STATE OF NORTH CAROLINA
DEPARTMENT OF TRANSPORTATION

SUBJECT: **Addendum #1 - Revised**
Contract DI00174
Grading, Drainage, Paving and Culvert on SR 1170 (Dull Road) – Culvert 133
Over Ellison Creek

REPLACE CULVERT #133 ON SR 1170 DULL ROAD
OVER ELLISON CREEK

CULVERT DESIGN DATA

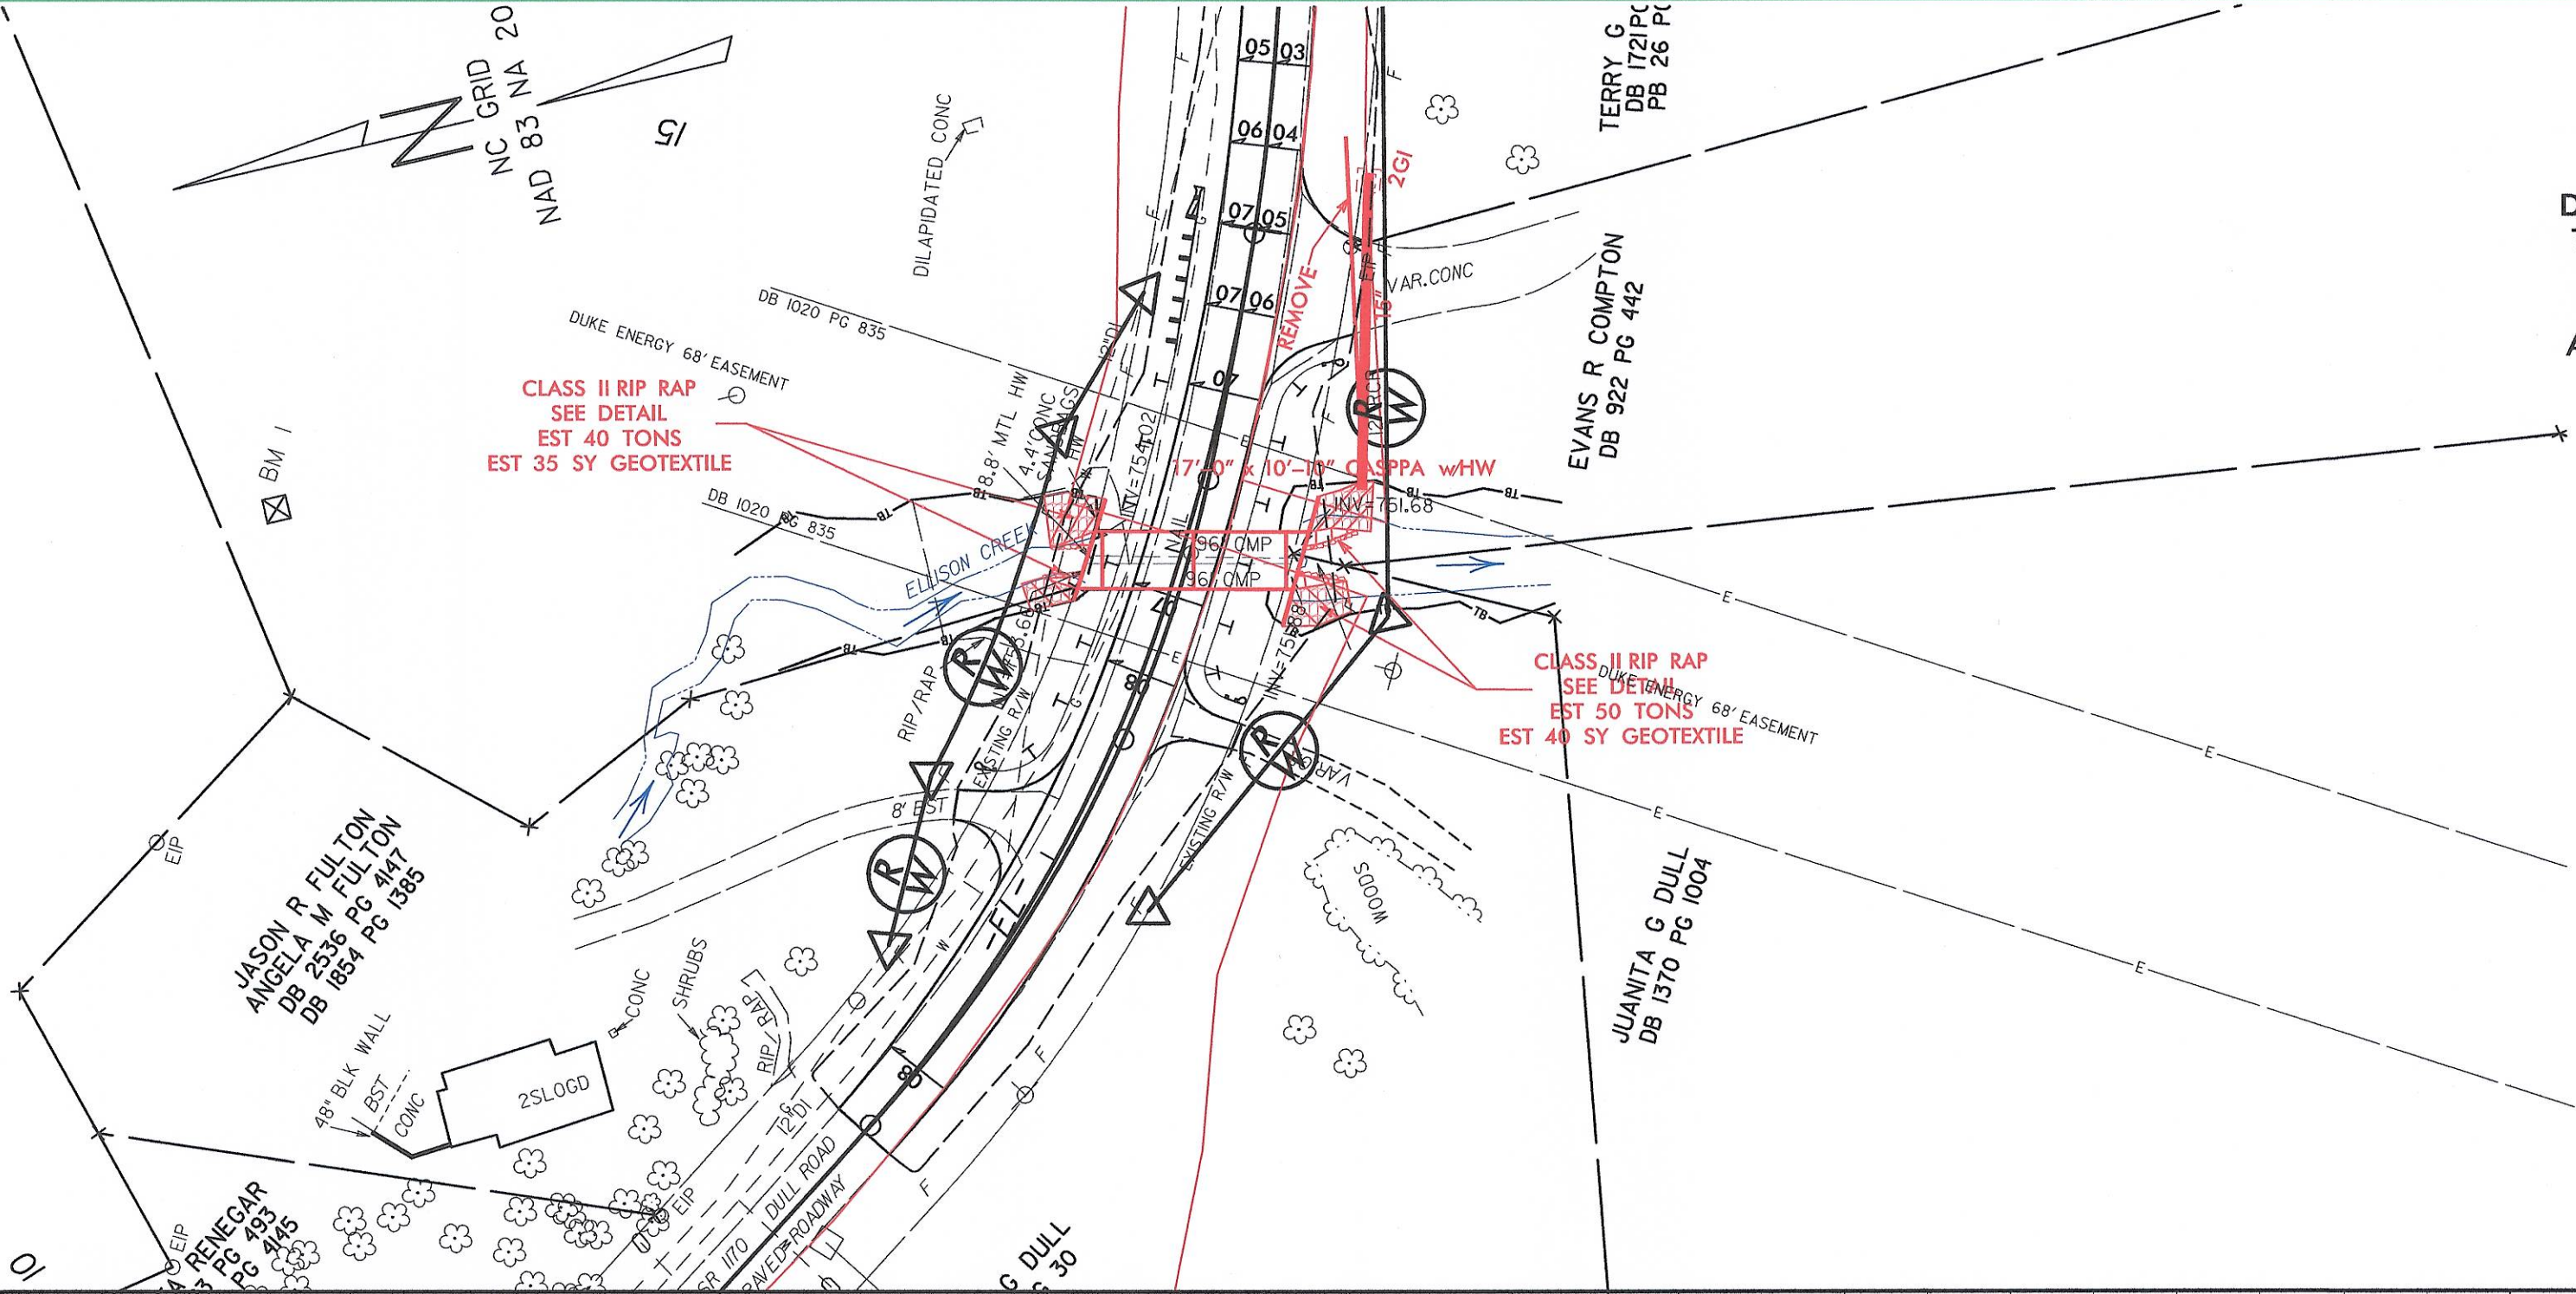
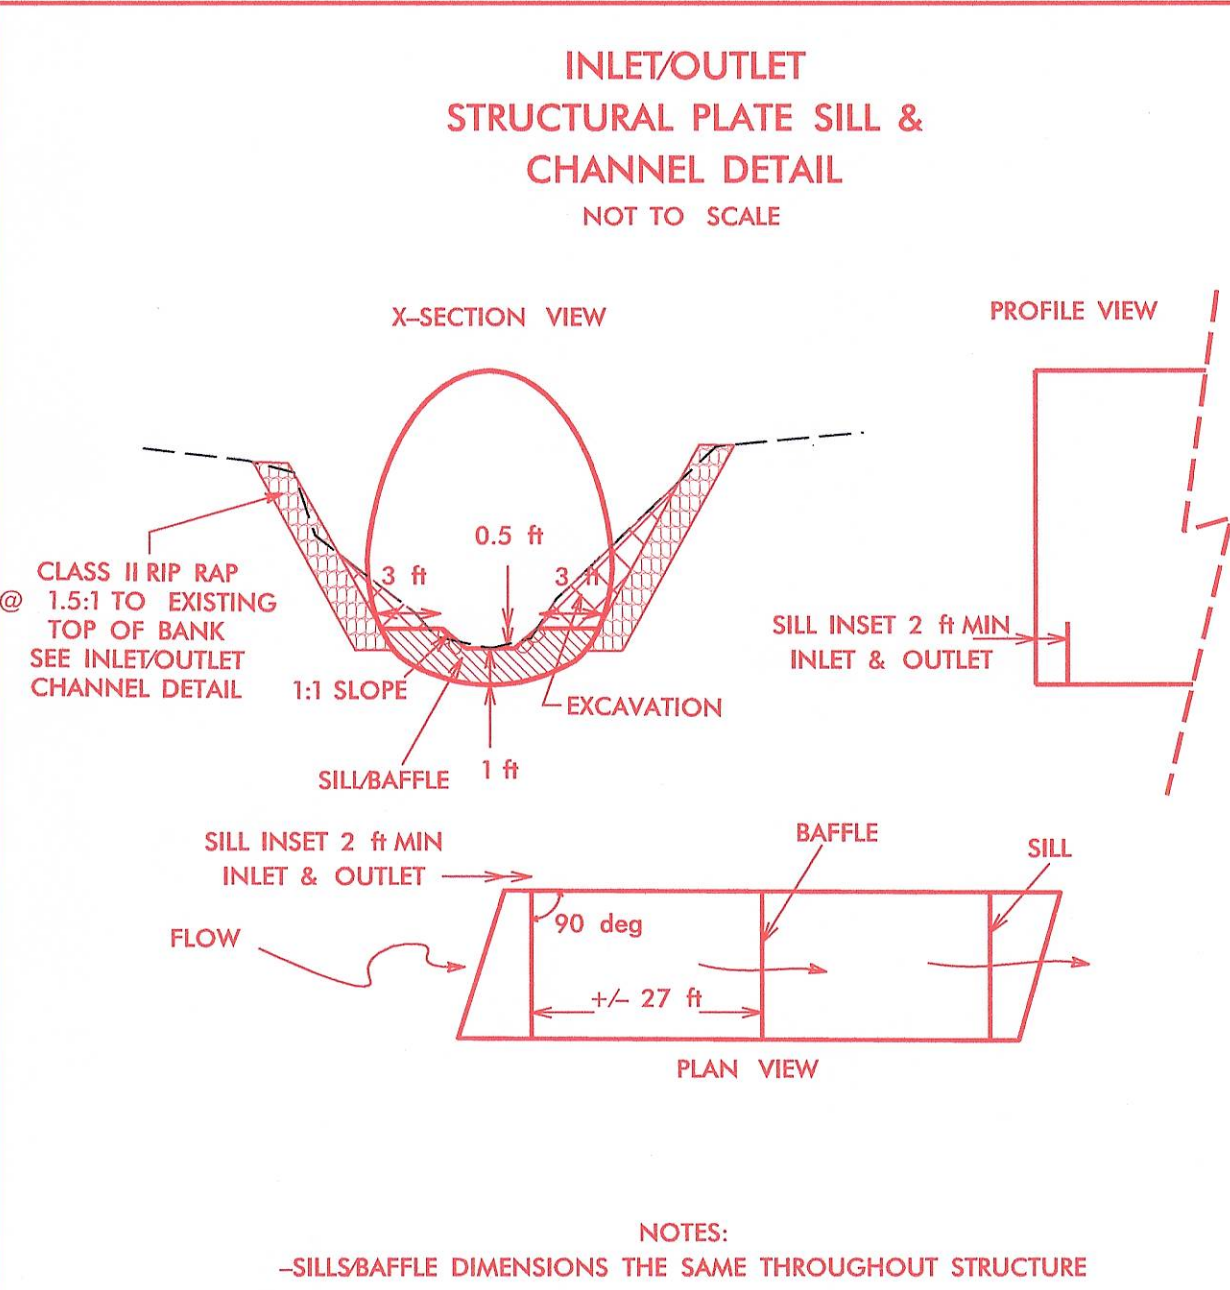
1. Add the attached plan sheet to existing plans for clarification.
